# FIRST DRAFT MINUTES

## February 21, 2013 Standards Committee Meeting (Changes by the Action of the Standards Committee and minor editorial revisions shown highlighted **yellow**)

RE: Minutes from the February 21, 2013 Standards Committee Meeting

REVISION TO STANDARD DRAWINGS  
 805-SGCF-04 SIGNAL HANDHOLE (WITH MARKUPS)

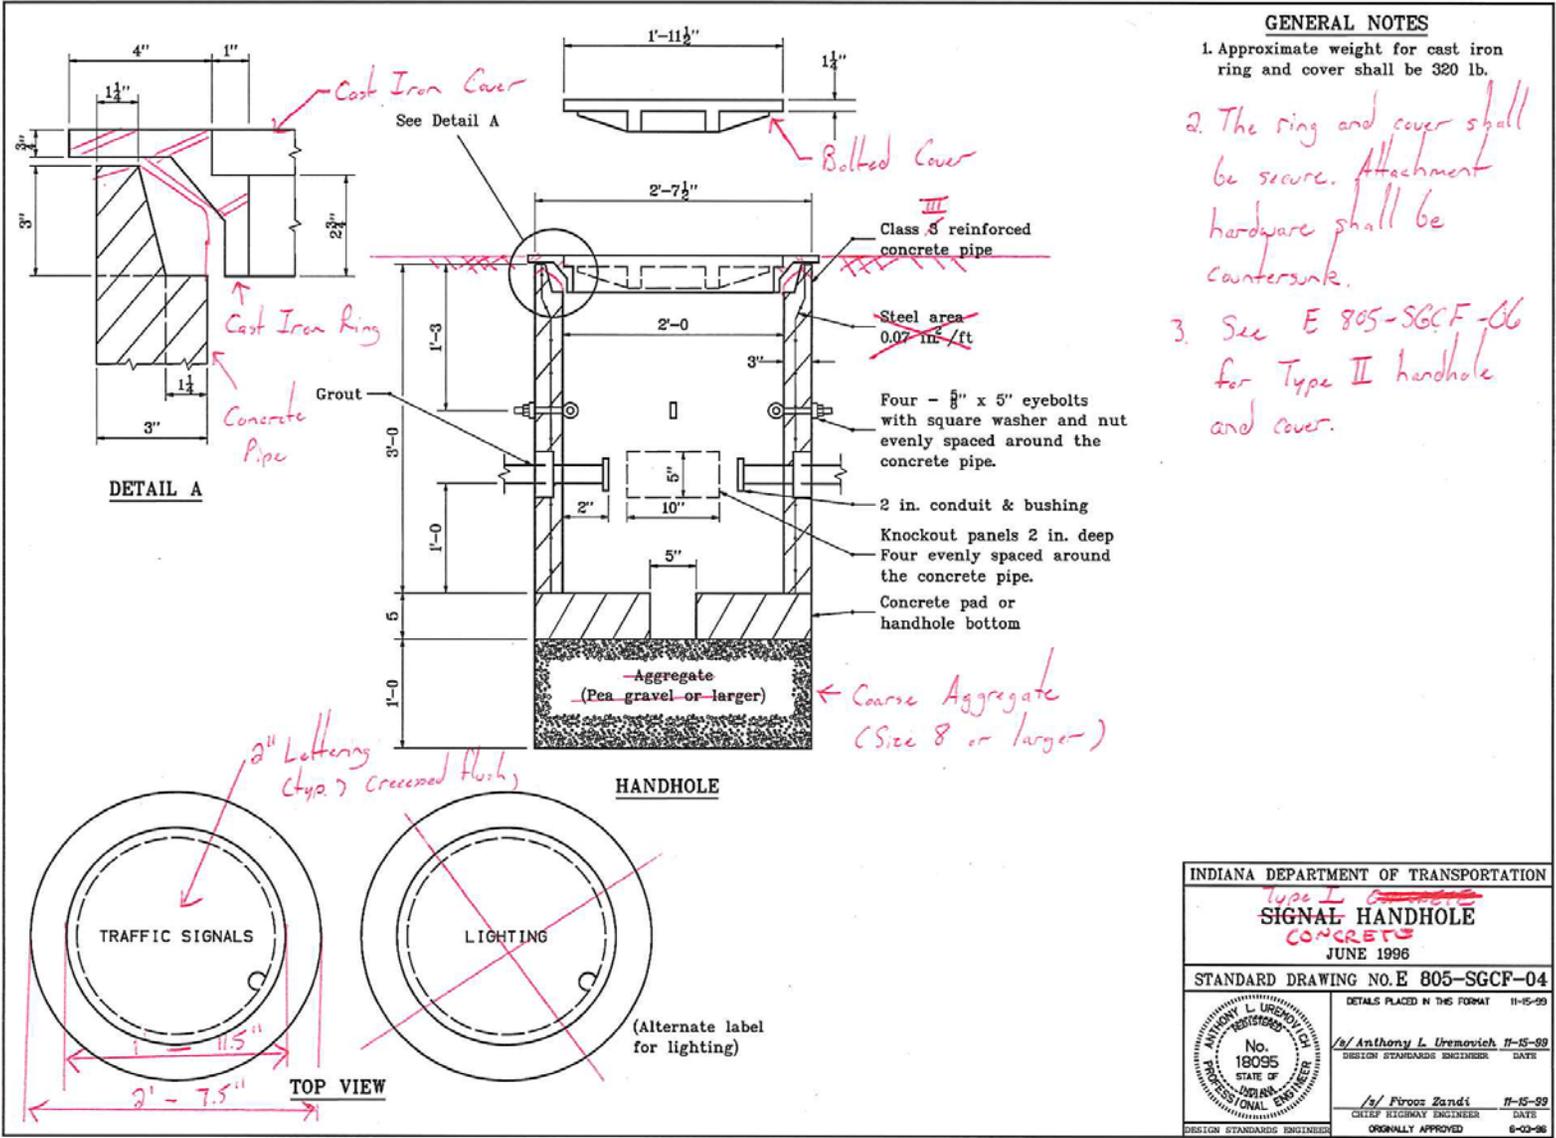
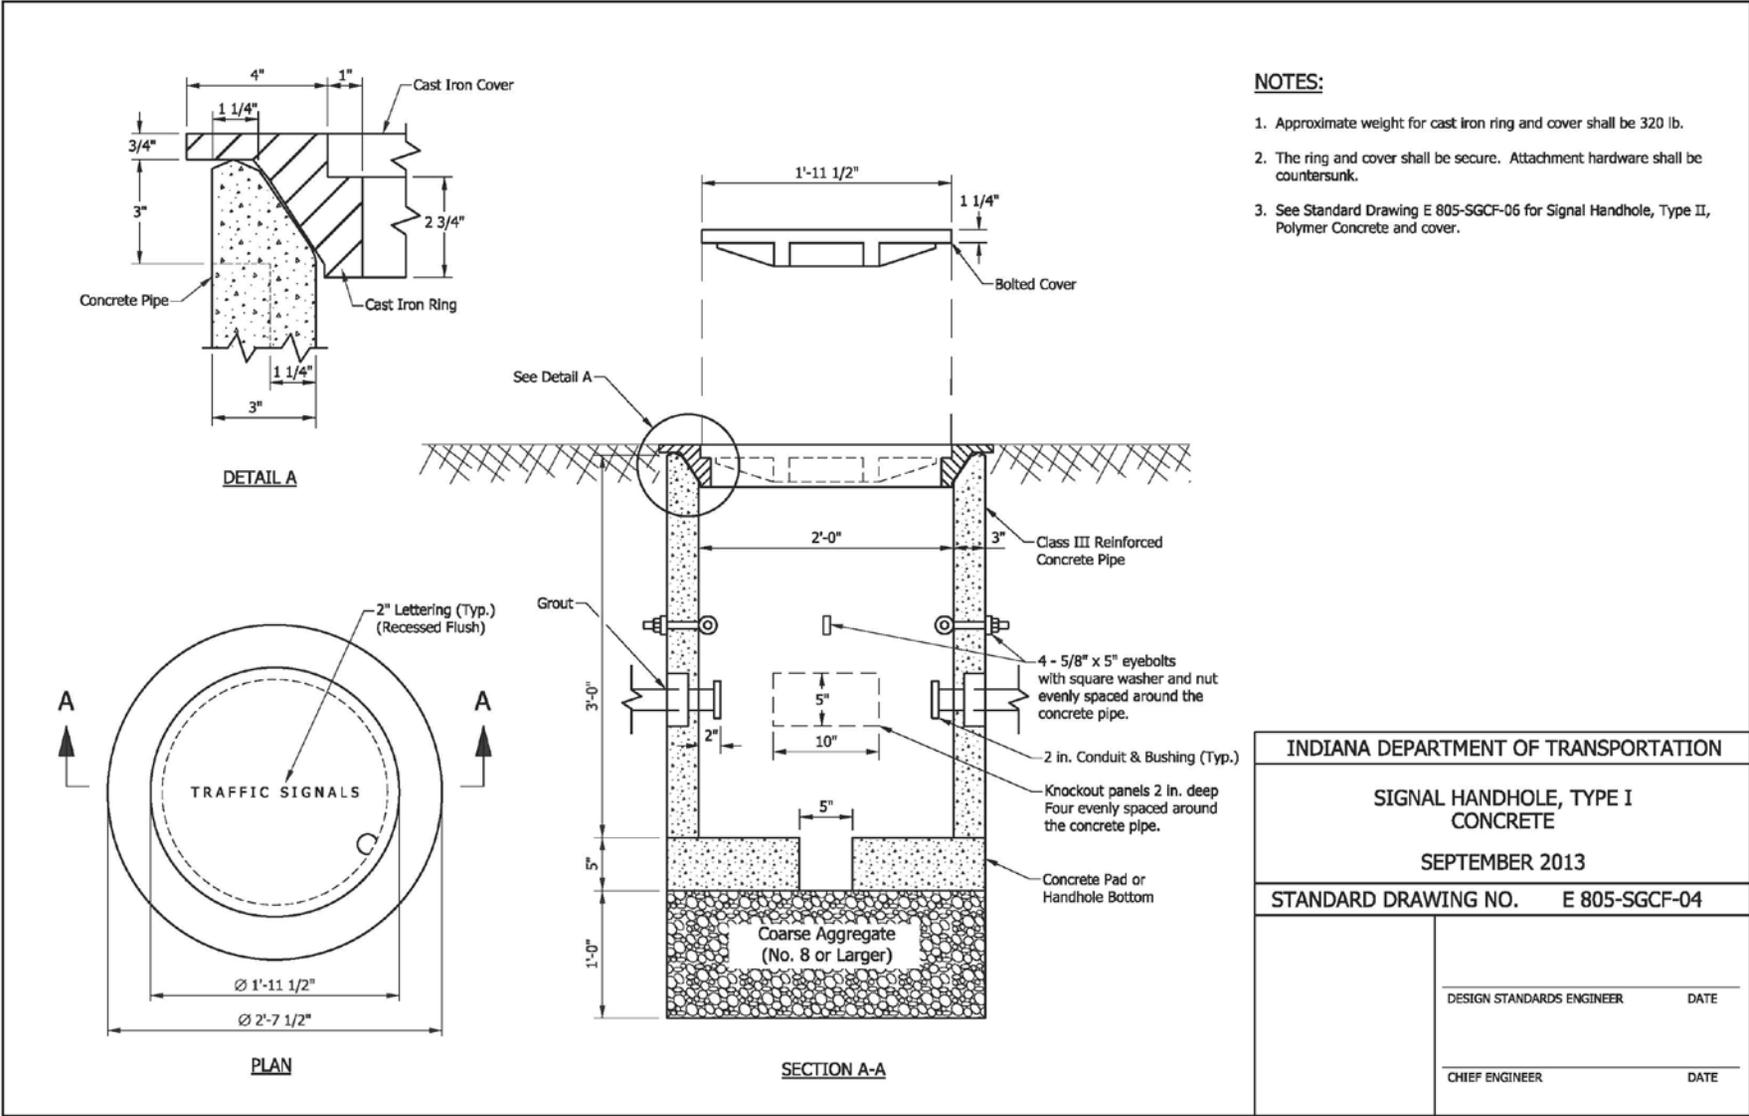
Revise Standard Drawing 805-SGCF-04 for concrete handholes and create a version for polymer concrete handholes. Delete Standard Drawing 805-SGLT-01.

STANDARD DRAWING NO. E 805-SGLT-01

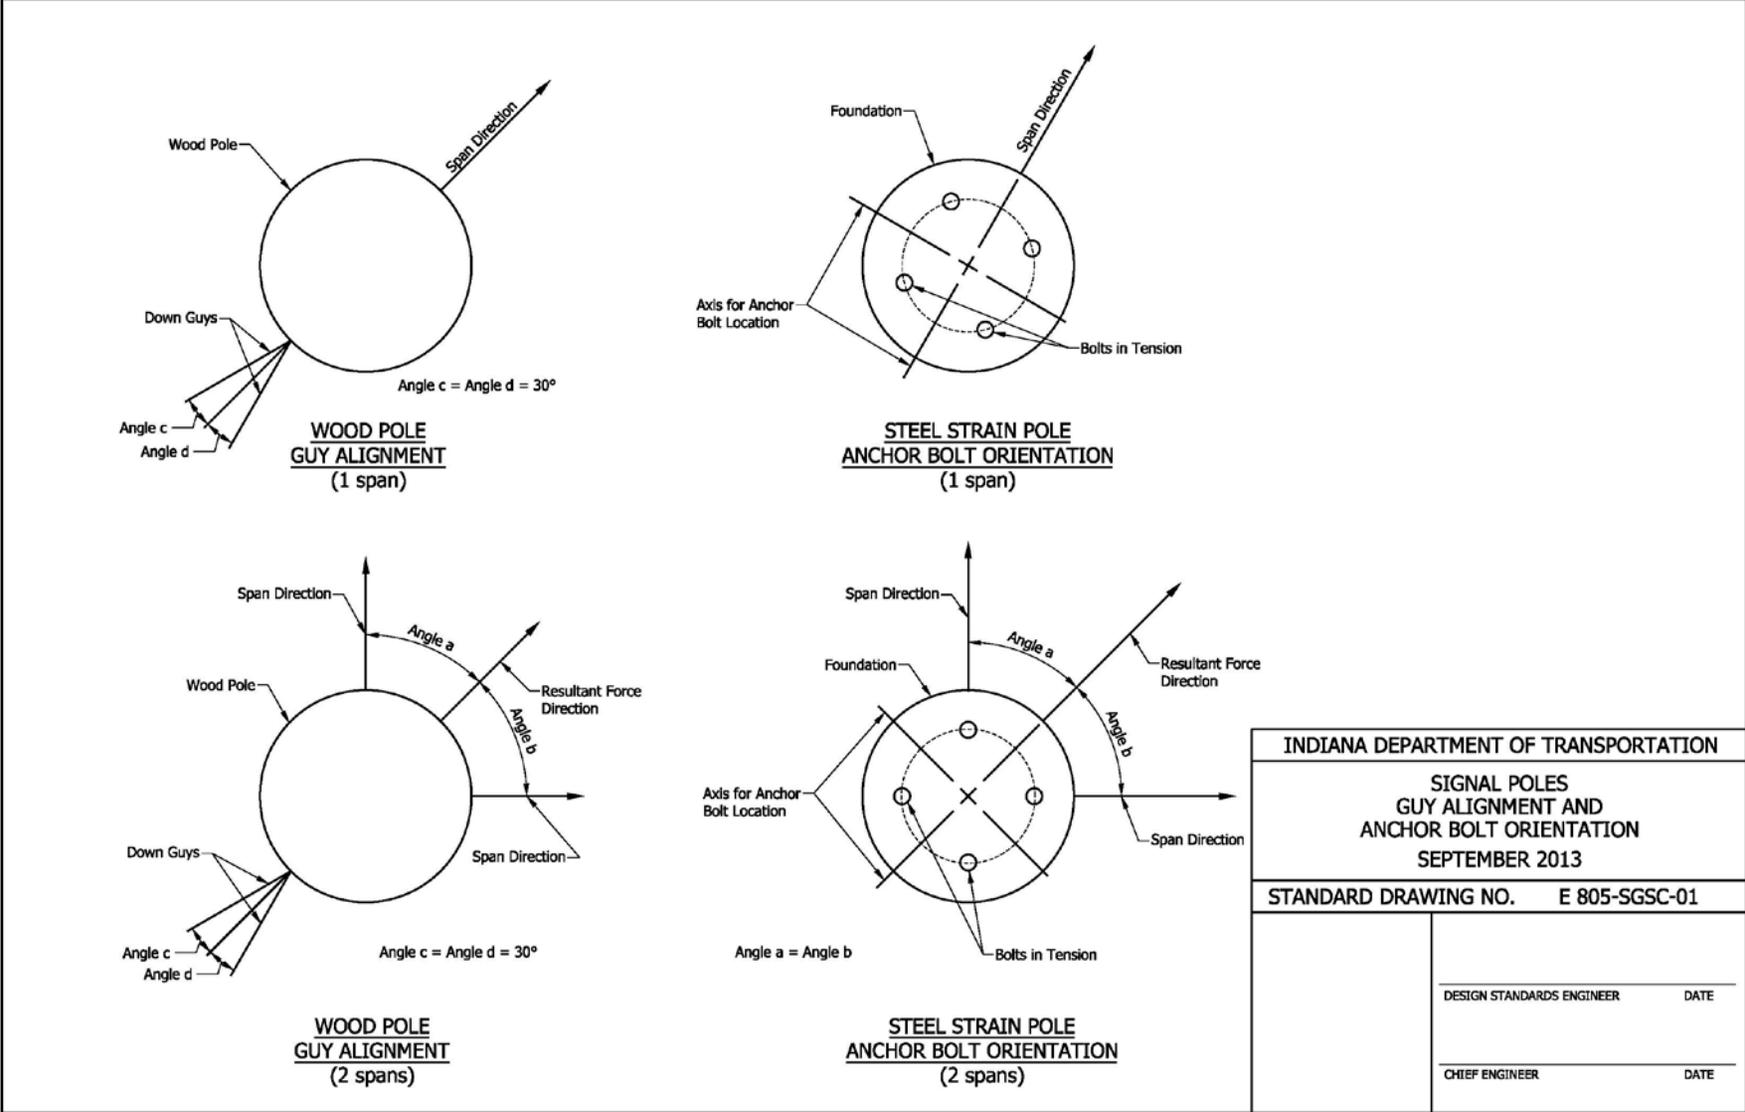
Standard Drawing 805-SGLT-01 detailing the loop tagging table is not accurate and is redundant since the designer provides this information (see Design Memo 12-13).

Item No. 04 02/21/13 (2012 SS) Ms. Phillips pg 144  
Standard Drawing:  
731-MSEW-01 MSE WALL PRECAST CONCRETE COPING

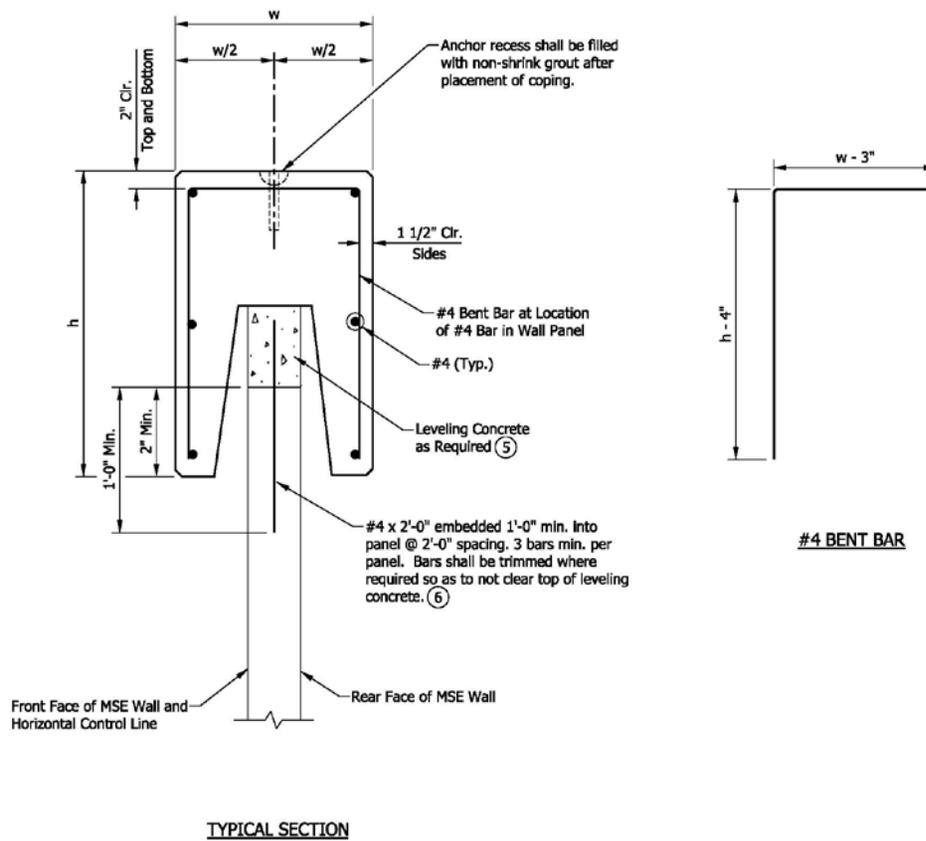
PROPOSED SOLUTION: Add notes clarifying use of leveling concrete to Standard Drawing 731-MSEW-01. No changes are proposed for the remaining drawings in the 731-MSEW series. No changes are proposed to the related Standard Specification 731 or active Recurring Special Provision 731-R-597. Leveling concrete will continue to be considered an "incidental" wall material and should be included in the cost of Face Panels, Concrete per 731.13.

1. Precast coping unit length shall be 10'-0".
2. Reinforcing bars' size, length, and spacing shall be determined by the manufacturer.
3. All chamfered edges shall be 3/4".
4. See Standard Drawing E 703-BRST-01 for reinforcing-bar bending details and notes.
- (5) Leveling concrete is required when adjacent top panels do not provide a continuous surface on which to place the precast coping, e.g., stepped panels or rectangular panels on a sloping grade. Leveling concrete is not required when custom top panels provide a surface parallel to the finished grade.
- (6) Use only when leveling concrete is required.

BACKUP 01. IDM, FIGURES 404-2B and 404-2C

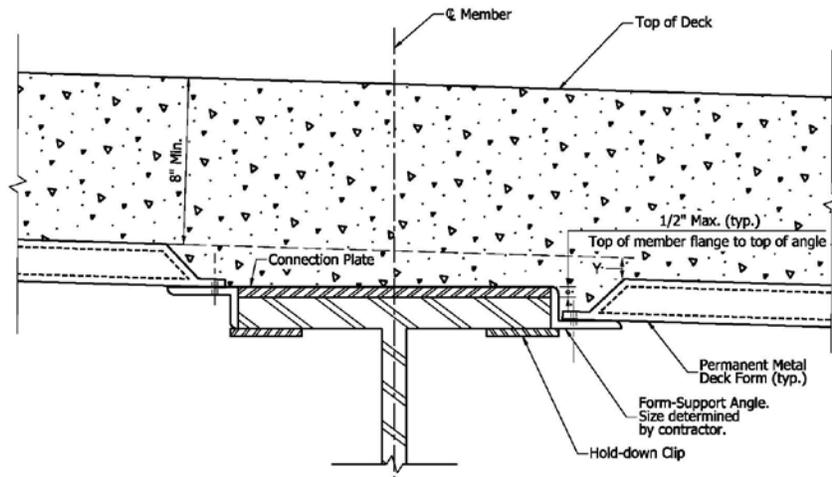
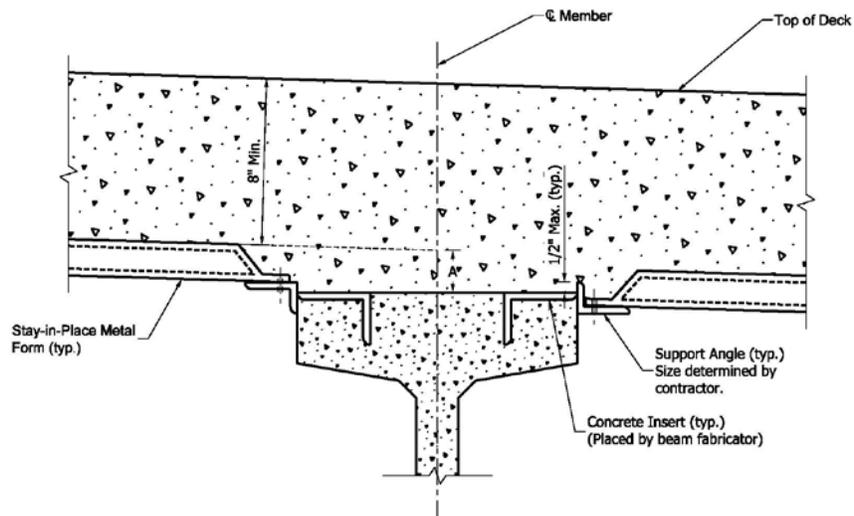
2. The improper installation of stay-in-place (SIP) metal deck forms can cause cracking. Limiting the projection of the form support above the top flange to 1/2 inch is considered adequate to reduce the likelihood cracks. Figures 404-2B and -2C illustrate the connection of SIP forms and instructs the designer to detail the connection on the plans. Because the engineer of record is not responsible for the design for the SIP forms, the plans are not the appropriate place for this information.

PROPOSED SOLUTION: Incorporate the proposed changes into the 702 section and to amend section 702.13 (e) 2. to limit the projection of the form support to a maximum of 1/2 in. above the top flange. Revise the Design Manual to refer to Figures 404-2B and -2C as typical connections and delete the requirement to detail the connection on the plans.
